March 1, 1993

RE: Hexcel Corporation  
ECRA Case No. 86009

HEXCEL CORPORATION  
Lodi, New Jersey  
FIGURE 1: START UP TASKS

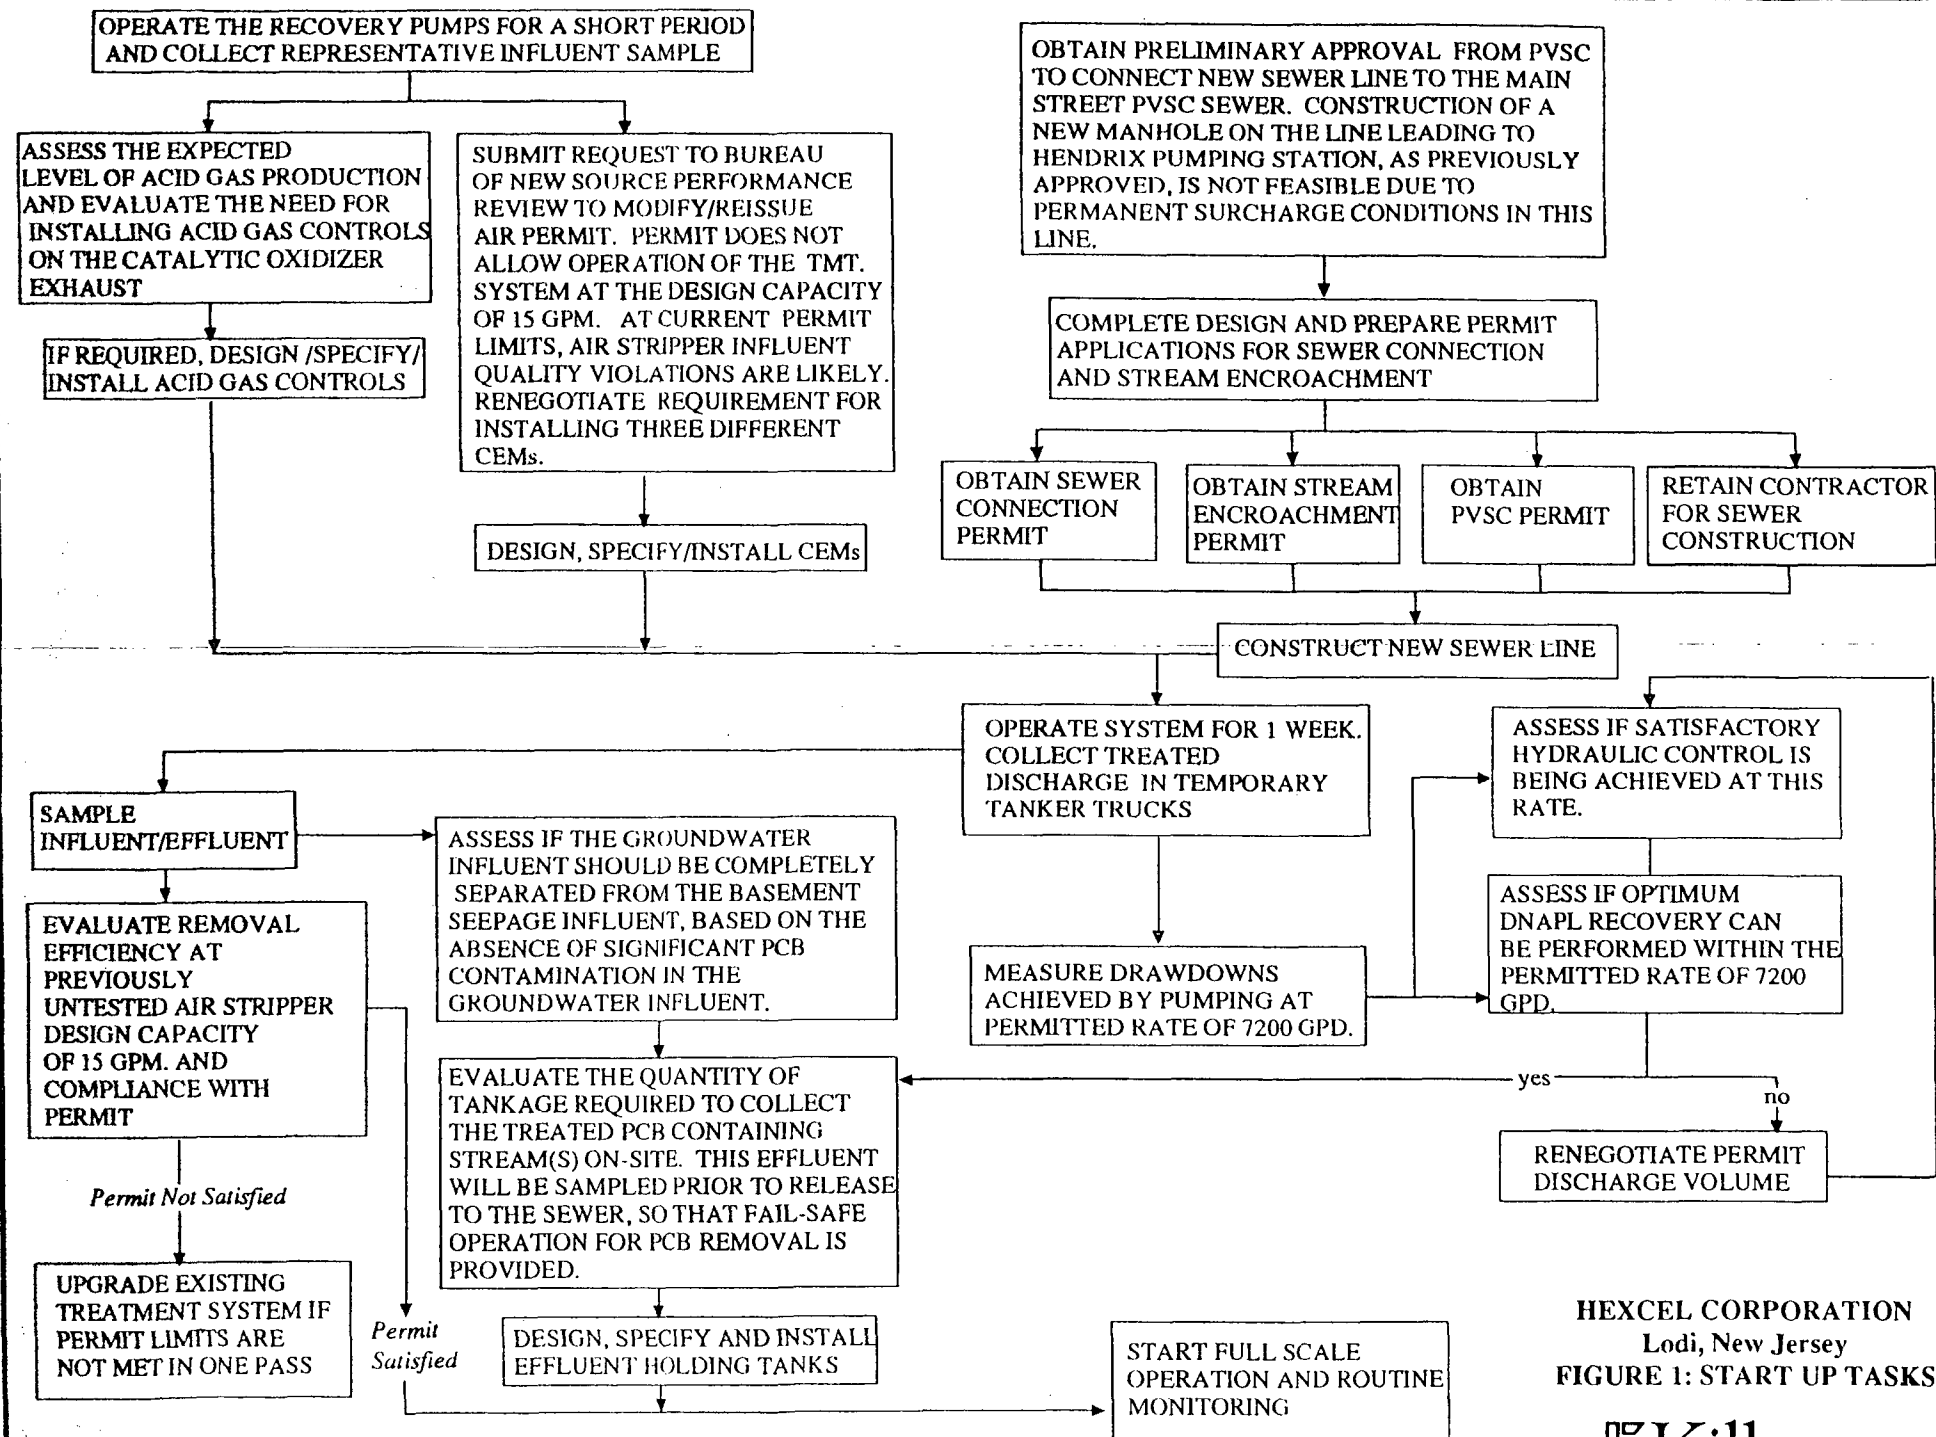
- Item 15. A detailed schedule for system start up and all related tasks is attached. Figure 1 presents a summary of the tasks to be performed as part of the start up procedures. Figure 2 presents a time line schedule for groundwater remedial tasks. Please note that if Fine Organics agrees to the renewal of the combined Hexcel/Fine Organics permit, the start up date will most likely be moved up by about 3 to 4 months.
